## **Appendix A**

### **Transport consultation meeting minutes**

<b>Project title</b>	Homebush Bay Bridge	<b>Job number</b>
		221379
<b>Meeting name and number</b>	Traffic Management and Access Workshop - SOPA and Transport NSW: 1	<b>File reference</b>
<b>Location</b>	Arup Office	<b>Time and date</b>
		9.00 am 23 February 2011
<b>Purpose of meeting</b>	Gather input from Transport NSW and SOPA on the various transport requirements for the Homebush Bay Bridge proposal.	<b>Page 1 of 116</b>
<b>Present</b>	Chris Walsh, Transport NSW Edward Osiowy, Transport NSW Rick Graf, Graf Colin Henson, Arup Safiah Moore, Arup	Hillary Johnson, RTA Steve Kennet, SOPA Greg Dowling, Scott Carver Javier Valderrama, Arup
<b>Apologies</b>	Mike Cook, Arup	Brian Mander, STA
<b>Circulation</b>	As above

Figure 38 SK01 Workshop Illustration\_potential design speeds

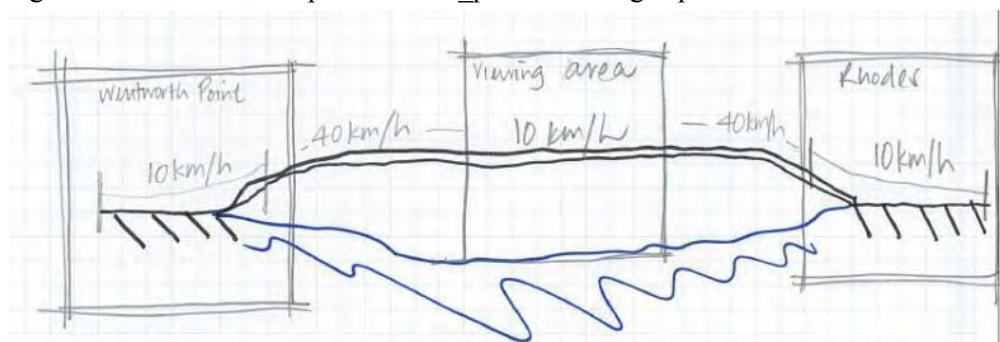
- Design of the bridge should convey understanding of traffic and pedestrian, cyclist interaction.
- 10km/h shared zones were explored at critical locations of the bridge as below and not endorsed as the space would not be appropriately self enforcing, given its disparate operational functions:

- RTA advised that a 10km/h design speed is required for shared

zones and is only appropriate to self enforcing environments such as short laneways in built up urban areas.
